RE: **6-ZN-2023 and 2-GP-2023**

Sundown Commons

6C395 and 95S87

Planning & Development Services has completed review of the above referenced development application. The following comments represent issues or deficiencies identified by the review team and are intended to provide you with guidance for compliance with city codes, policies, and guidelines.

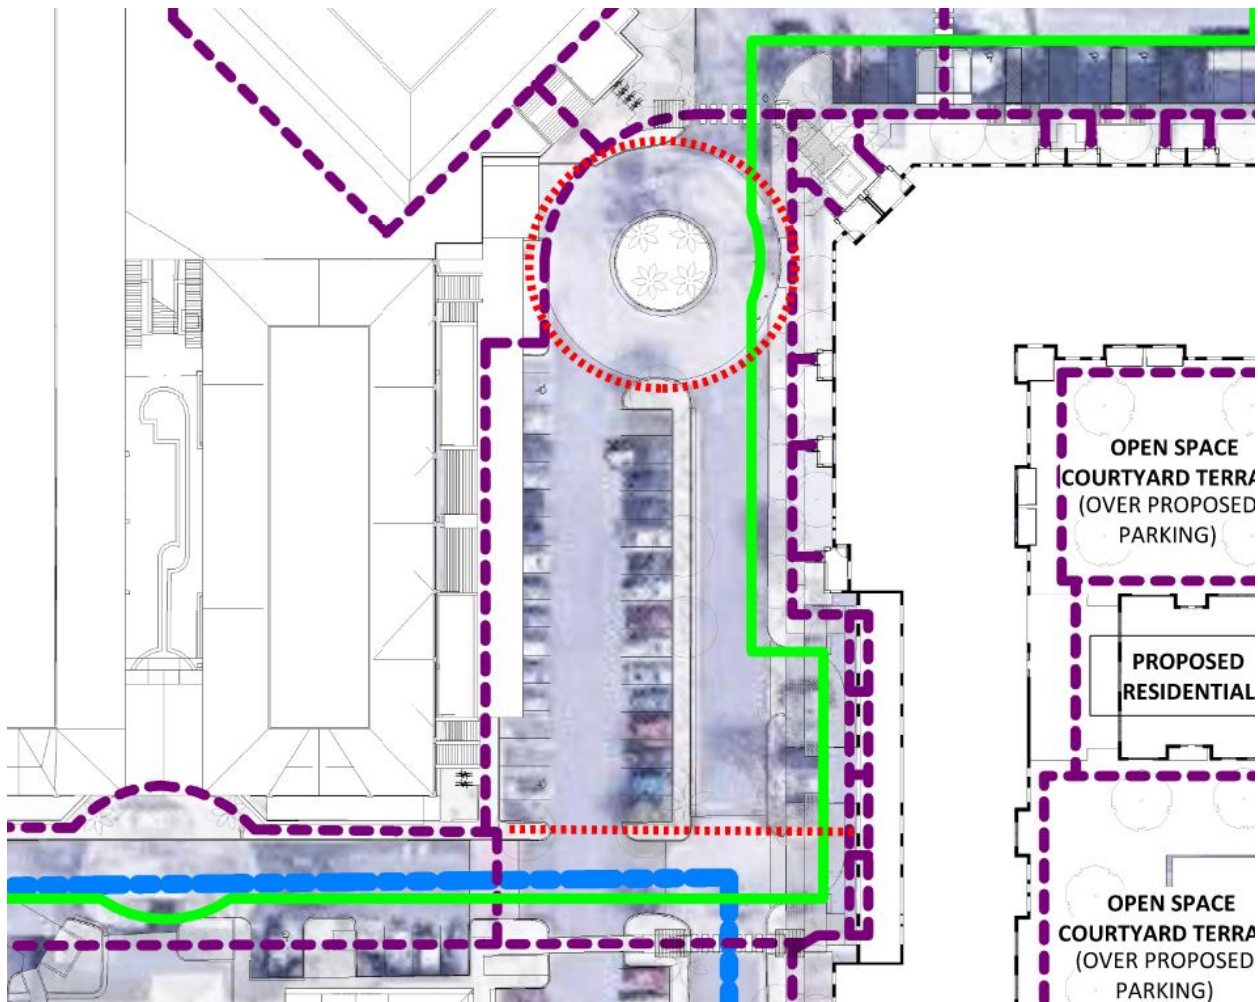
Please label the sidewalks as proposed on the site plan. Please see the proposed shopping center connections below in red and incorporate into the project plans.

Team Response: Additional pedestrian connections to the shopping center have been added.

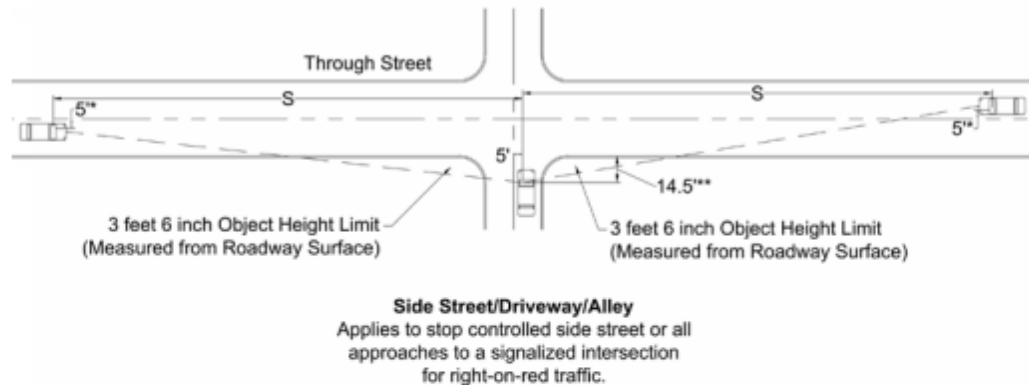
48. DSPM 3-1.701: Alley connection to street is to be reconstructed with project to create an ADA accessible pedestrian crossing and provide positive drainage. Update site plan accordingly.

Team Response: Alley connection to street will be reconstruction and ADA ramp crossing will be including during final design.
